SUMMARY OF CHANGES:

S4.55
DEVELOPMENT APPLICATION

COVER SHEET

URBN SURF SYDNEY
HILL ROAD, SYDNEY OLYMPIC PARK NSW

DRAWING
ILLUSTRATIVE MASTERPLAN

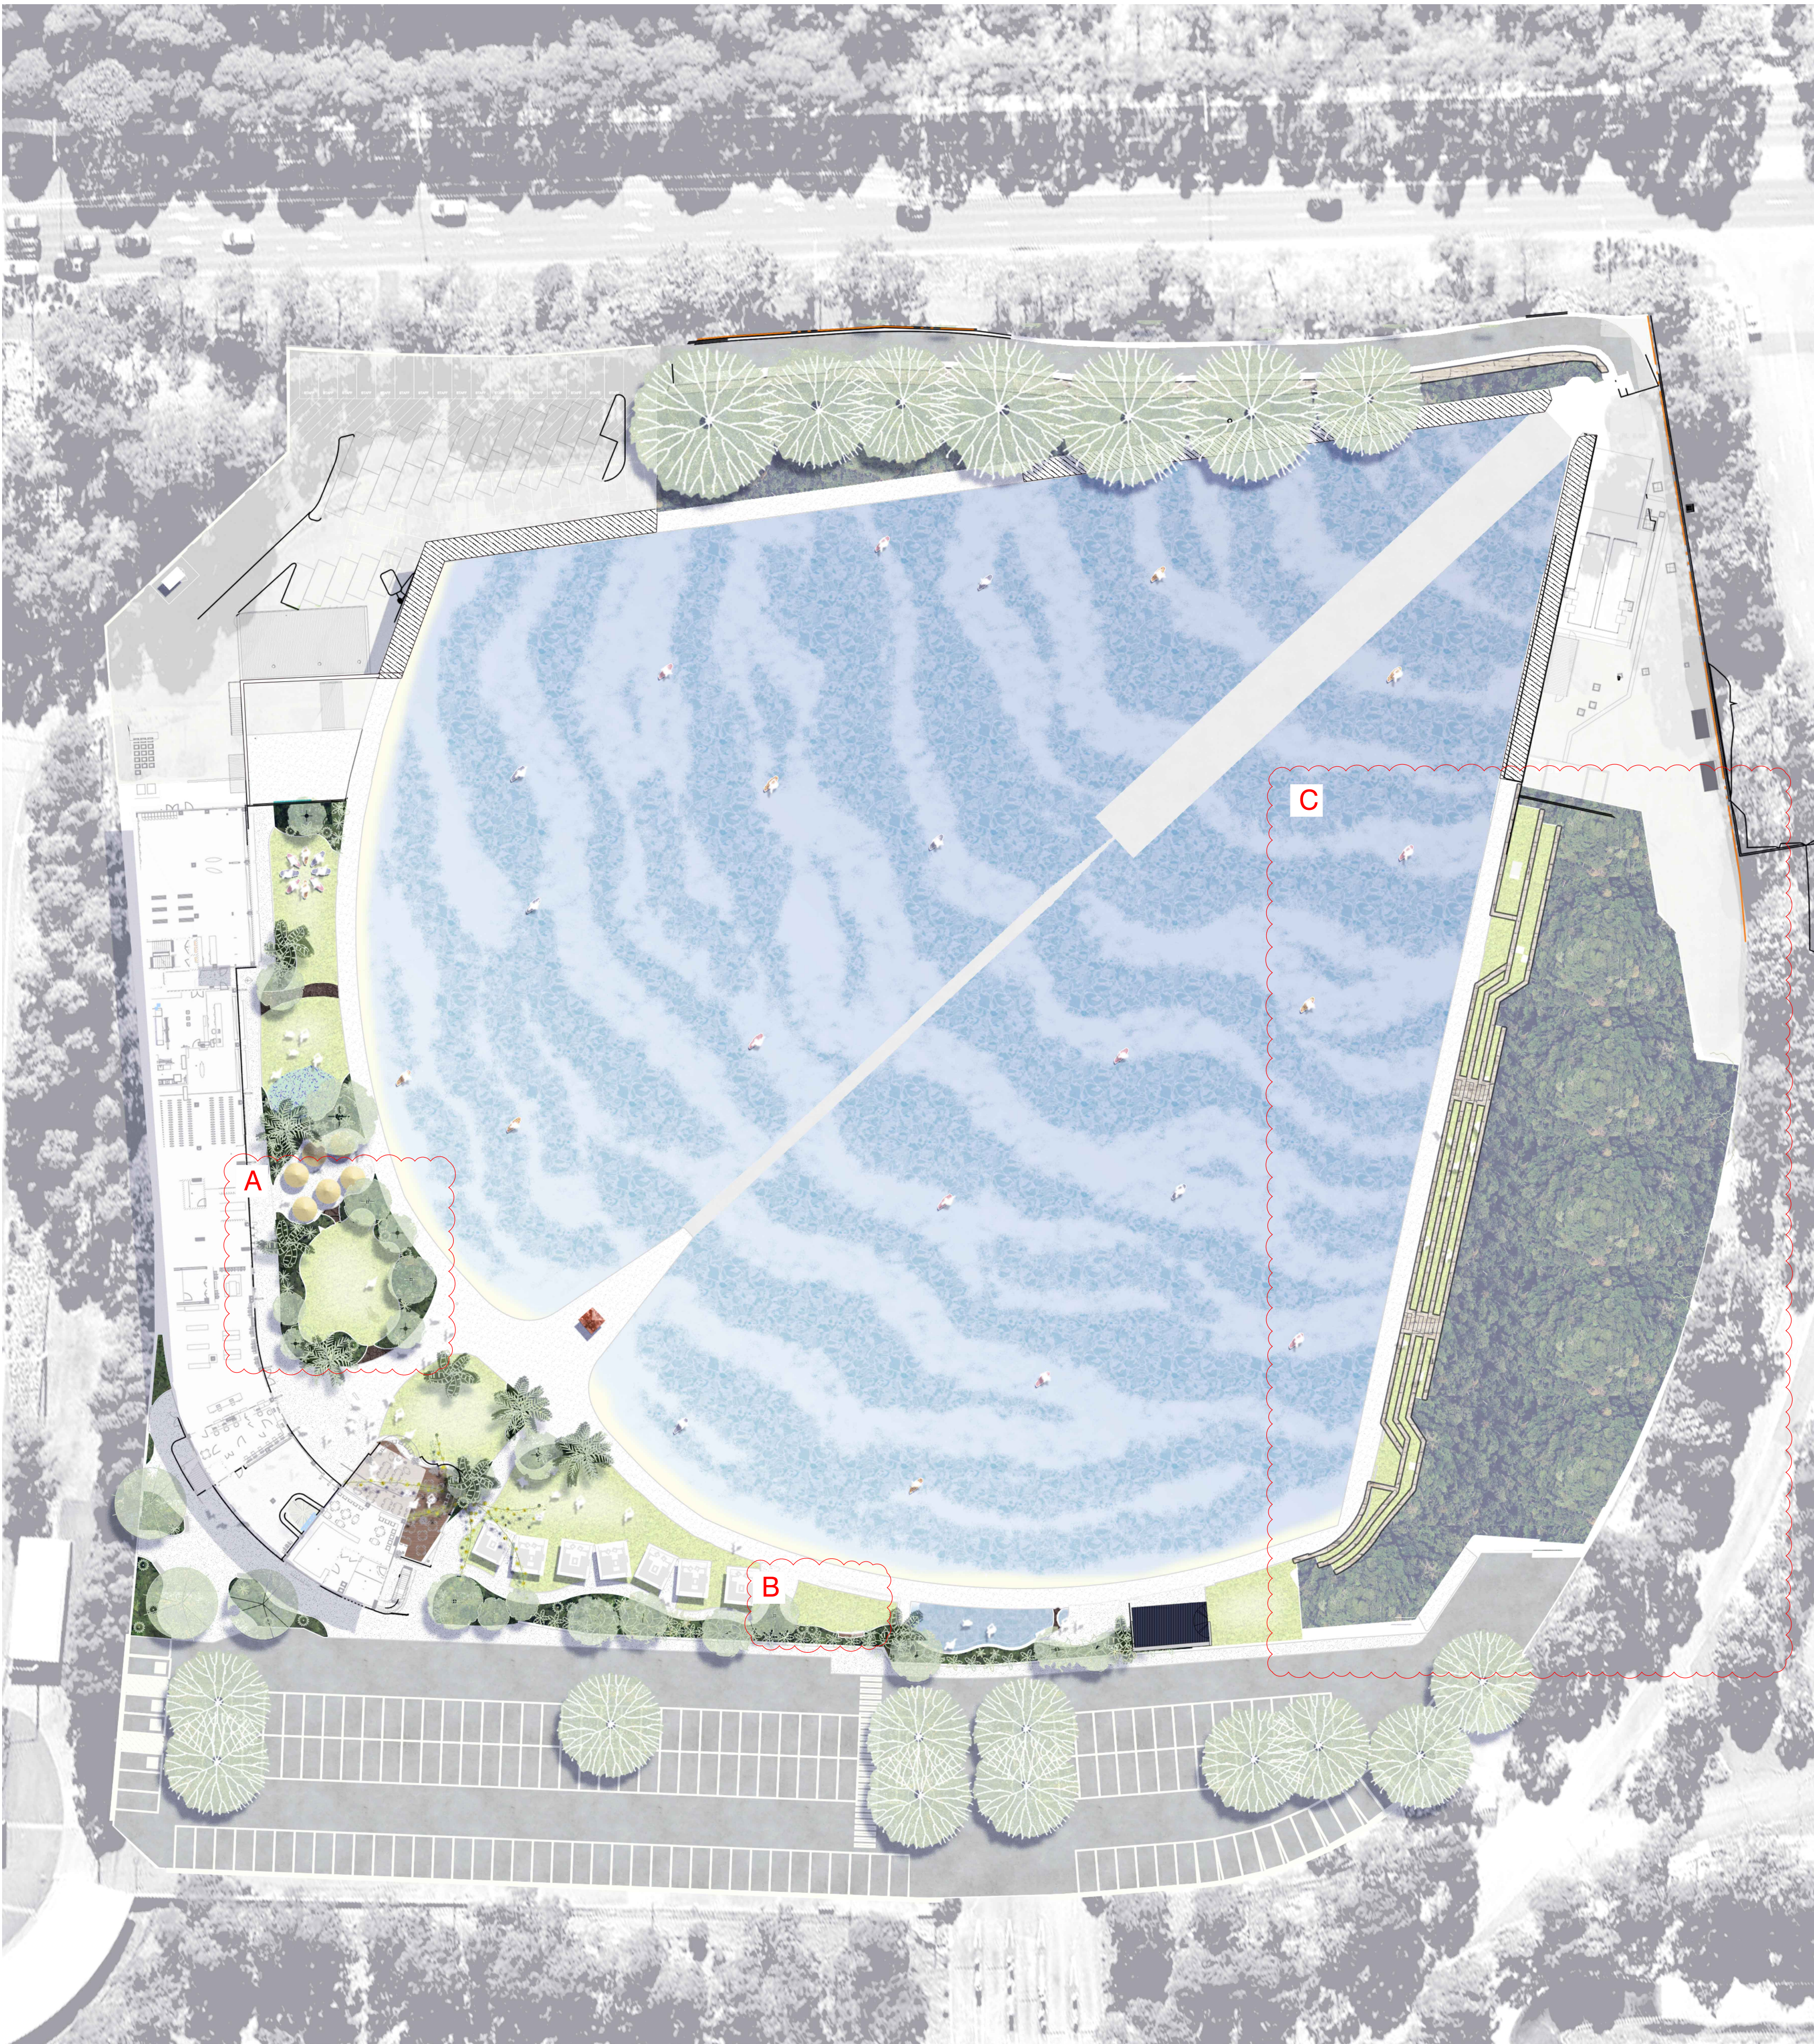
- A. NATURE PLAYGROUND REPLACED WITH FLAT LAWN SPACE
- B. KIDS POOL REPLACED WITH FLAT LAWN SPACE
- C. EVENTS HILL DESIGN UPDATED

DRAWING
SITE PLAN

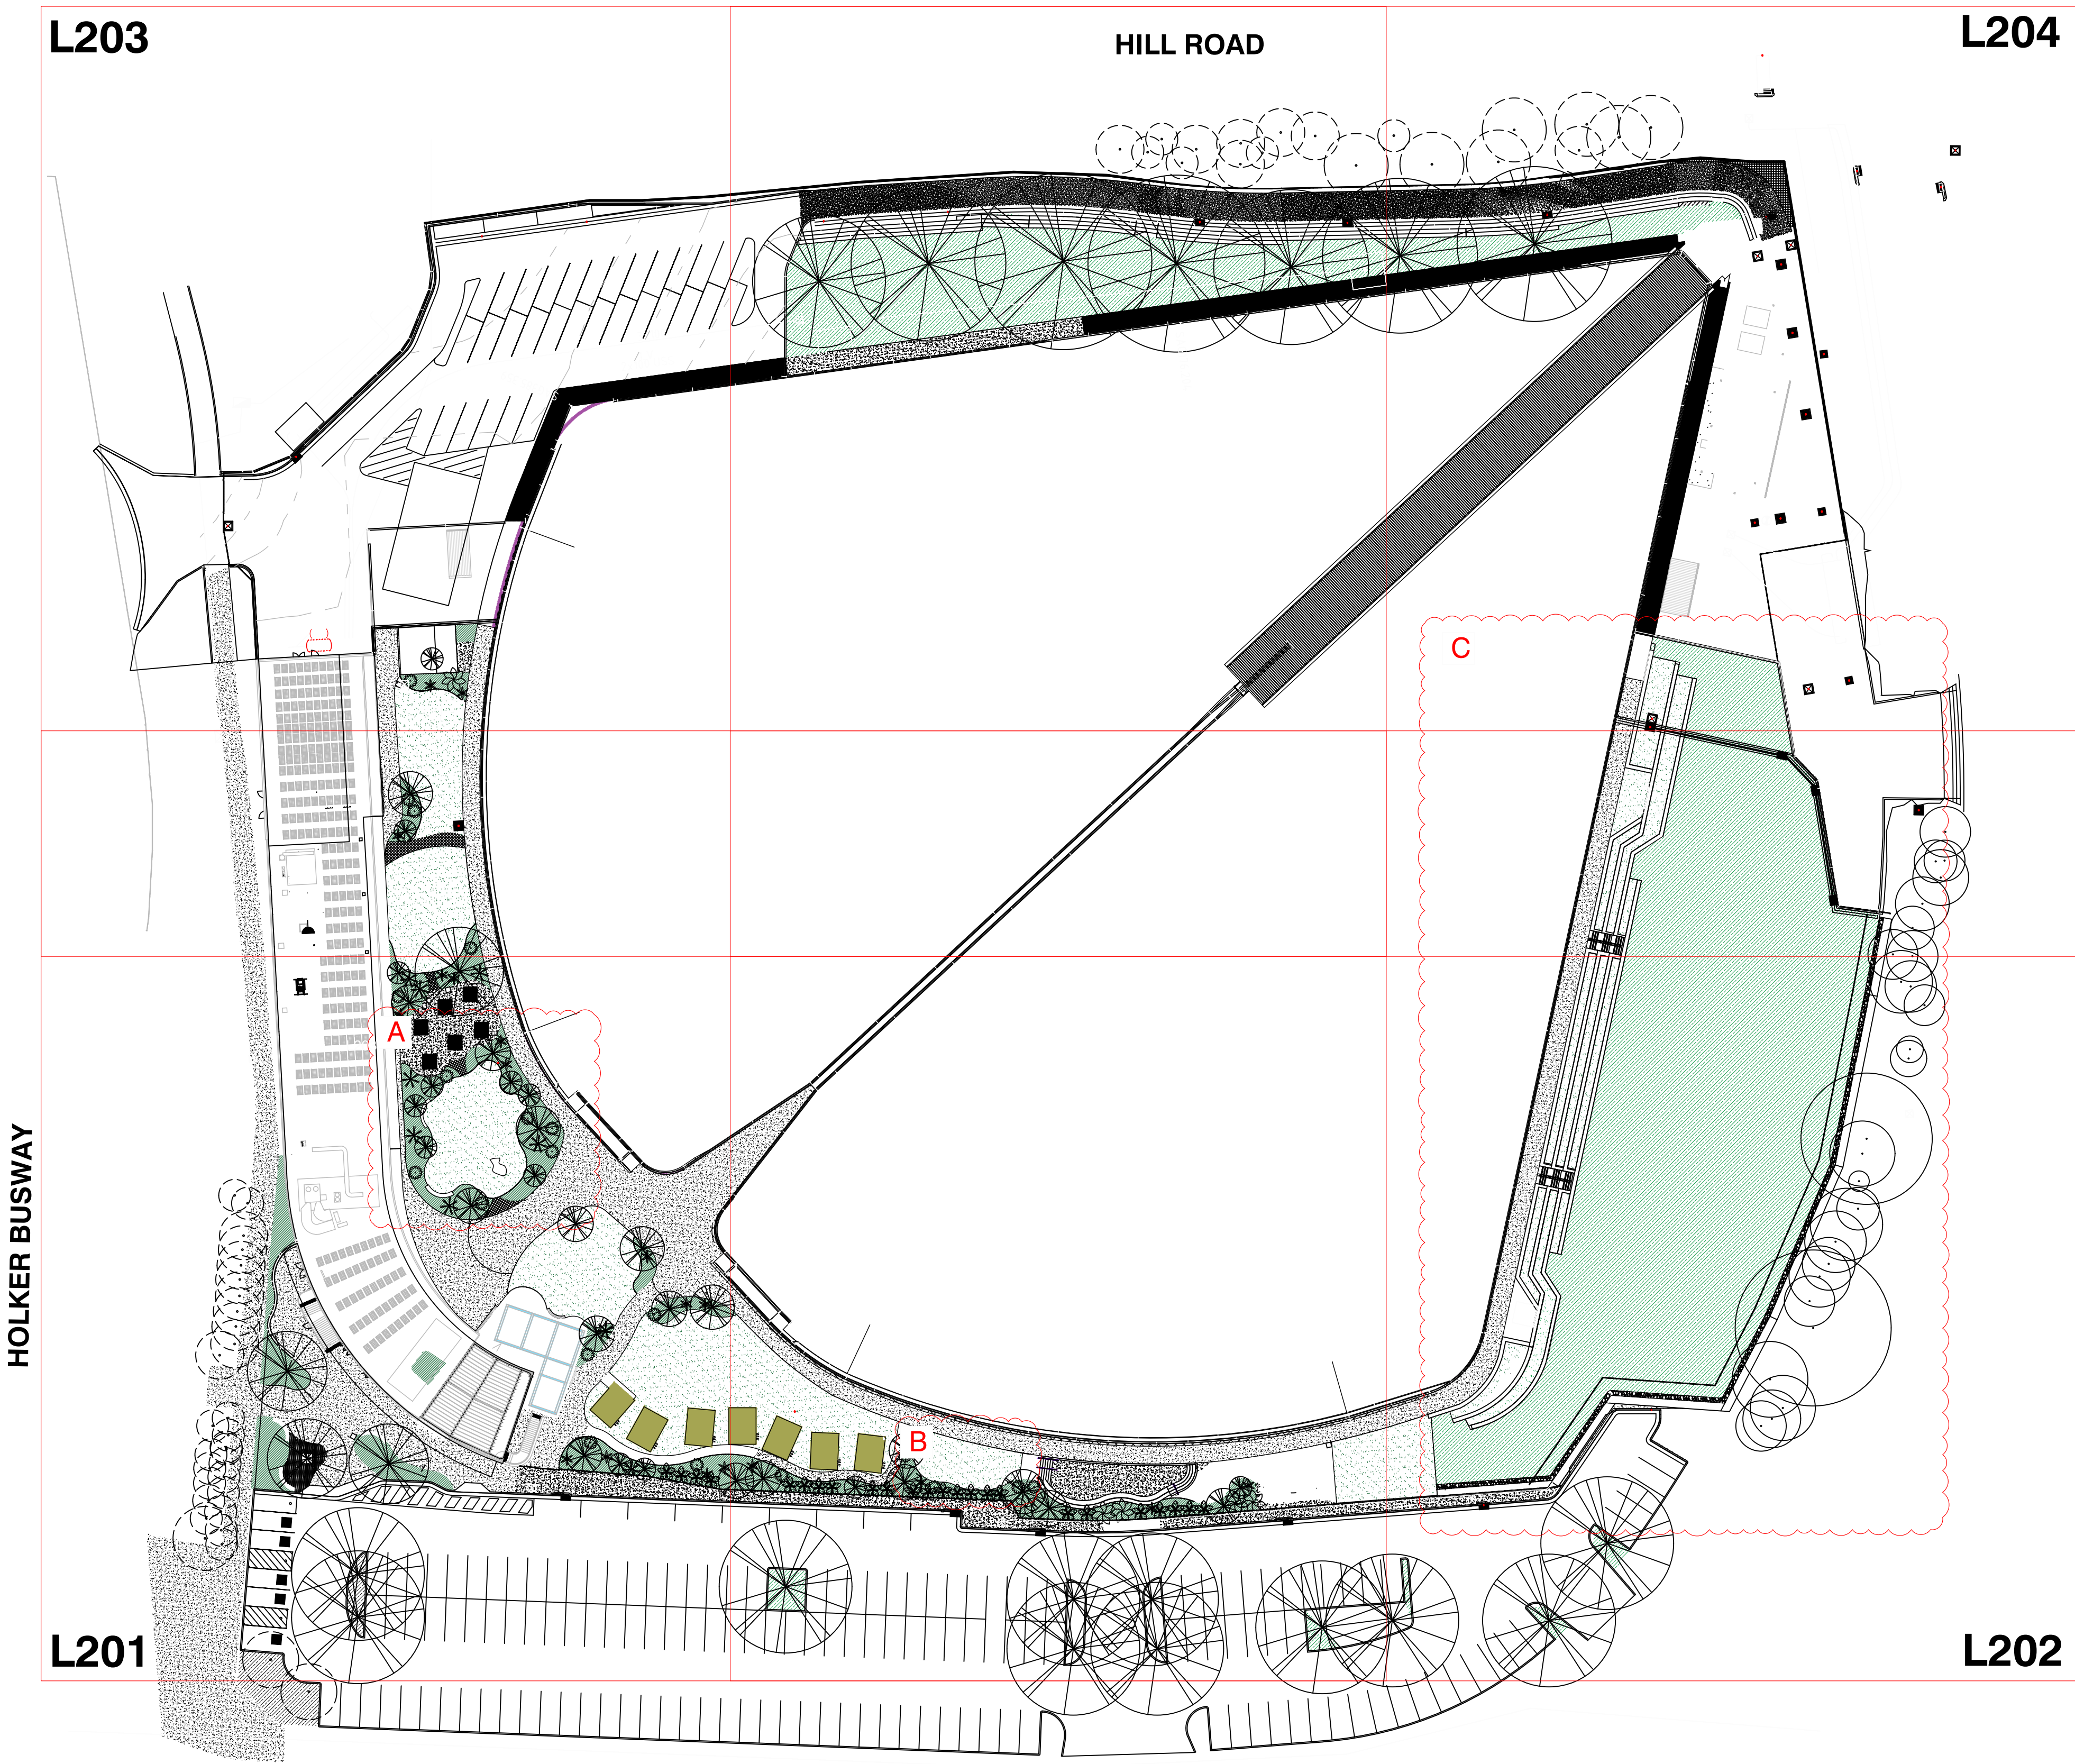
- A. NATURE PLAYGROUND REPLACED WITH FLAT LAWN SPACE
- B. KIDS POOL REPLACED WITH FLAT LAWN SPACE
- C. EVENTS HILL DESIGN UPDATED

DRAWING
SURFACE FINISHES
AND MATERIALS

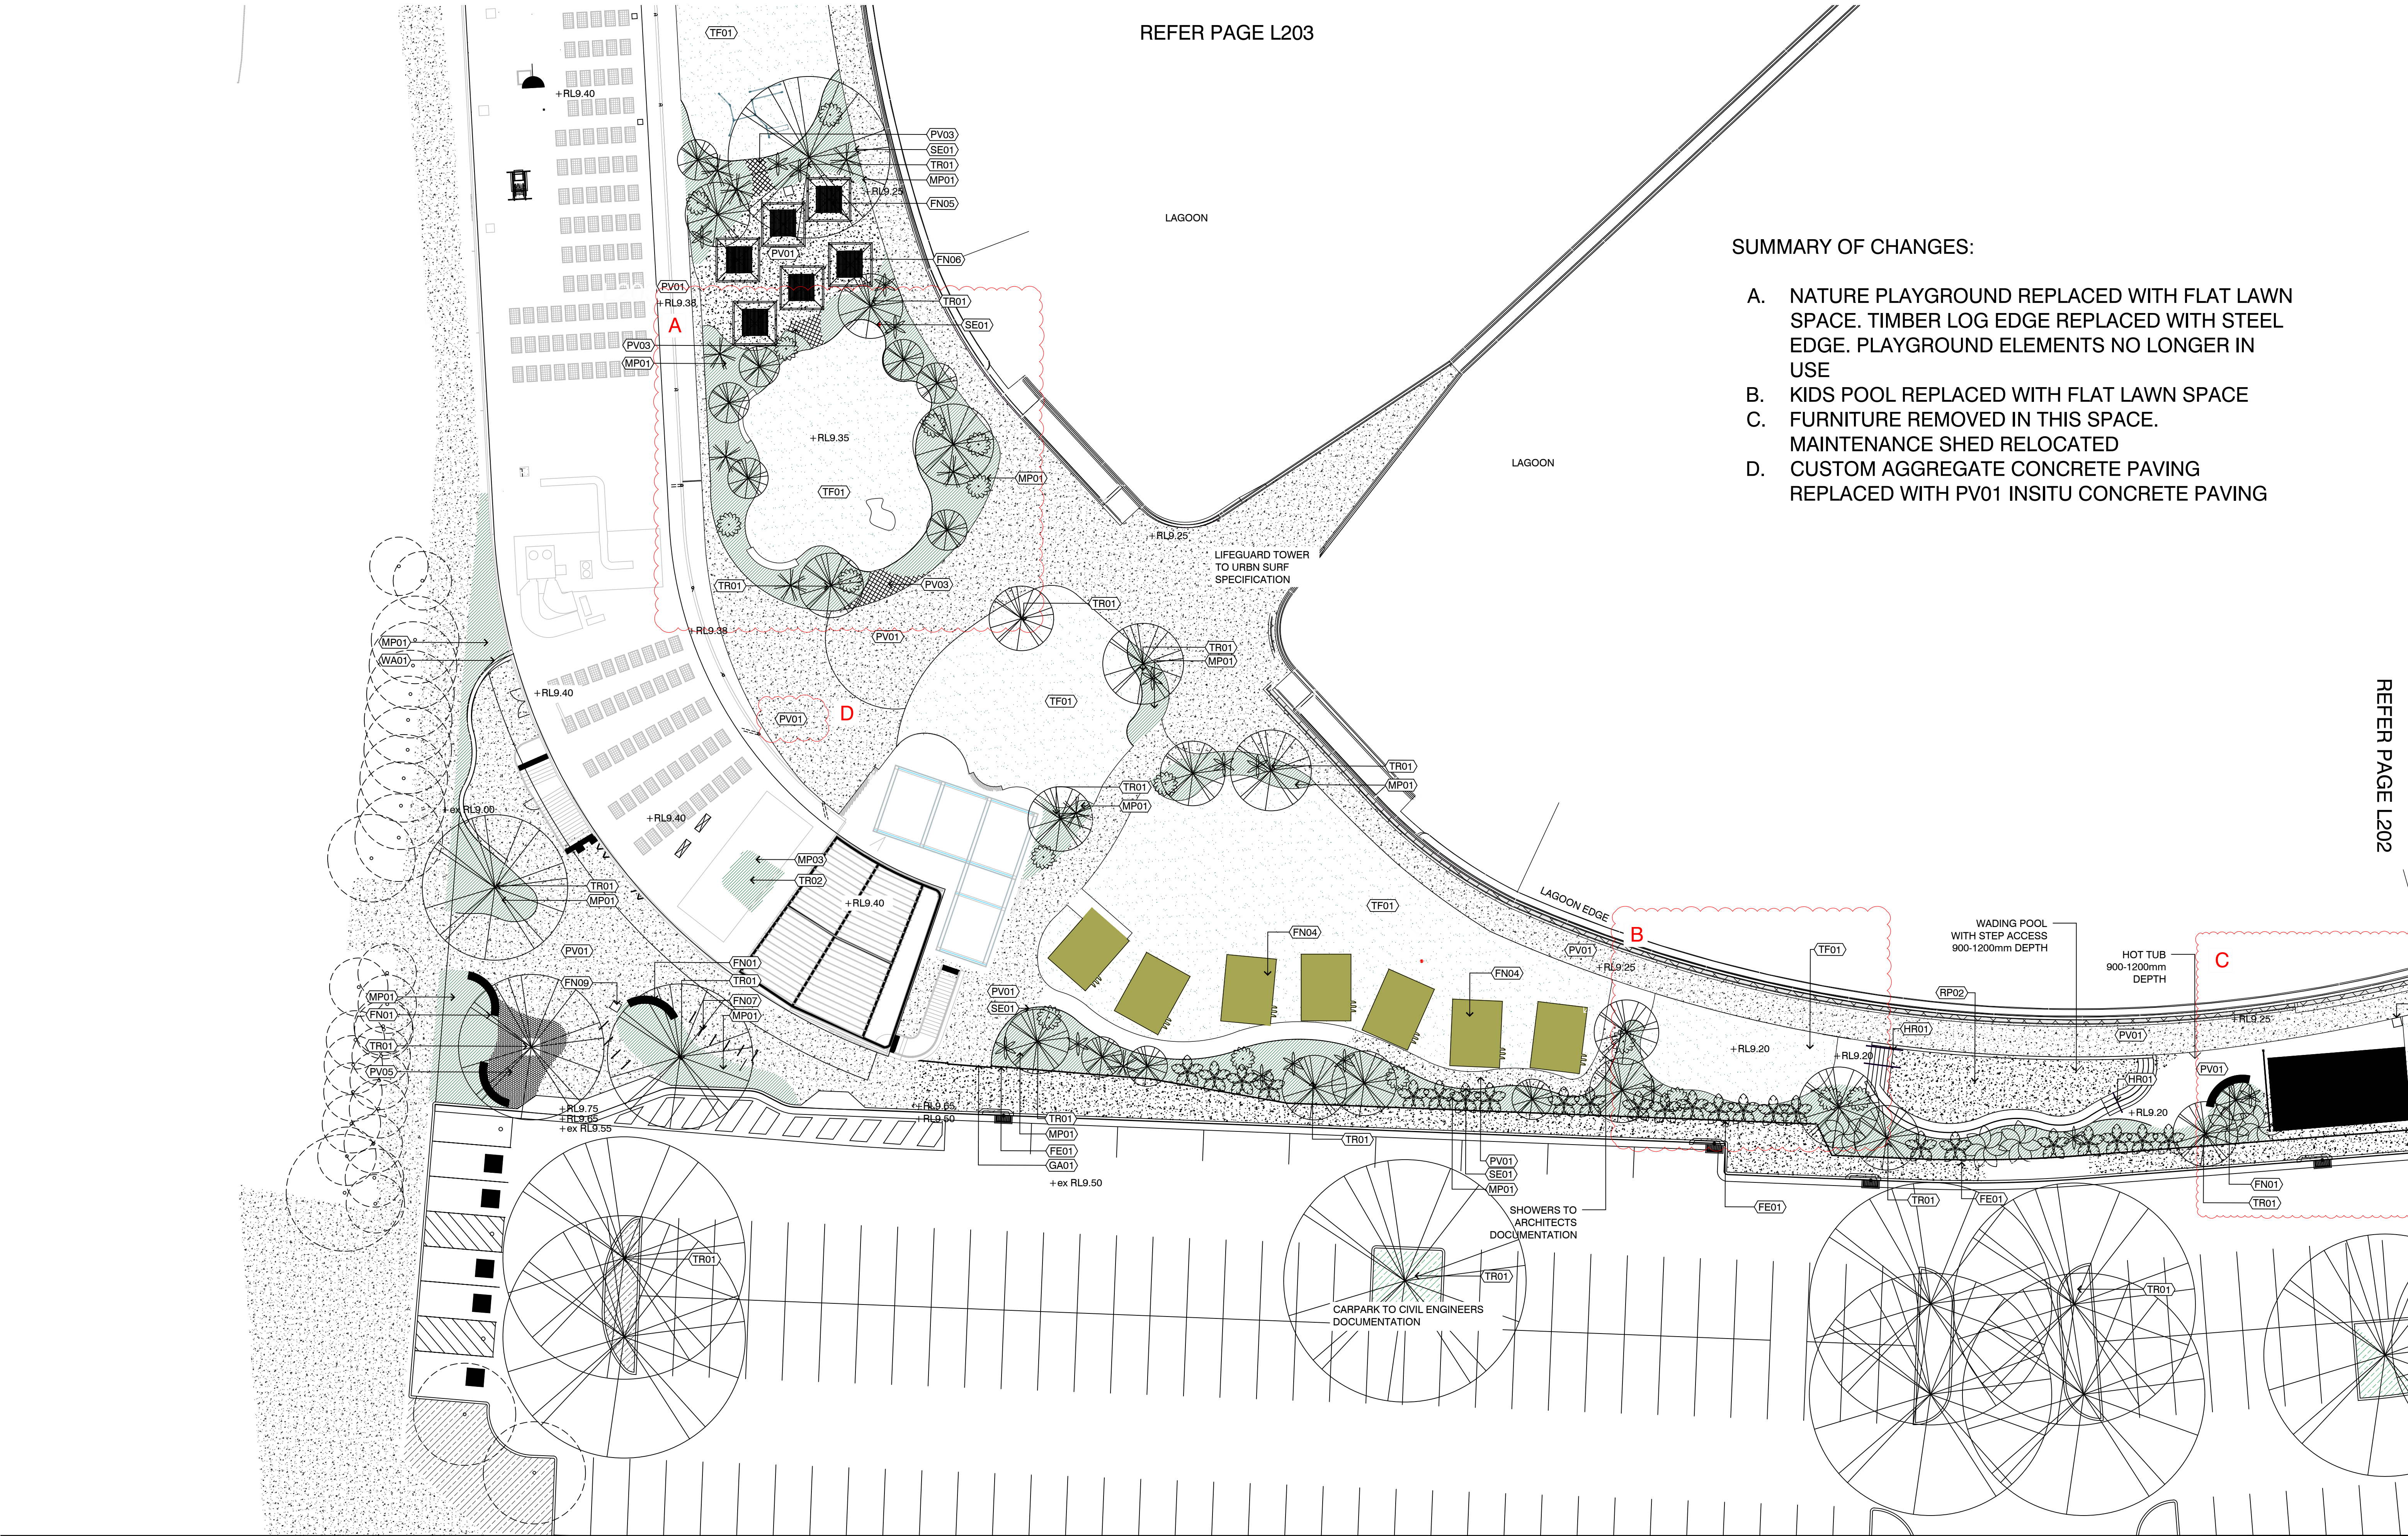
- A. NATURE PLAYGROUND REPLACED WITH FLAT LAWN SPACE. TIMBER LOG EDGE REPLACED WITH STEEL EDGE. PLAYGROUND ELEMENTS NO LONGER IN USE
- B. KIDS POOL REPLACED WITH FLAT LAWN SPACE
- C. FURNITURE REMOVED IN THIS SPACE. MAINTENANCE SHED RELOCATED
- D. CUSTOM AGGREGATE CONCRETE PAVING REPLACED WITH PV01 INSITU CONCRETE PAVING
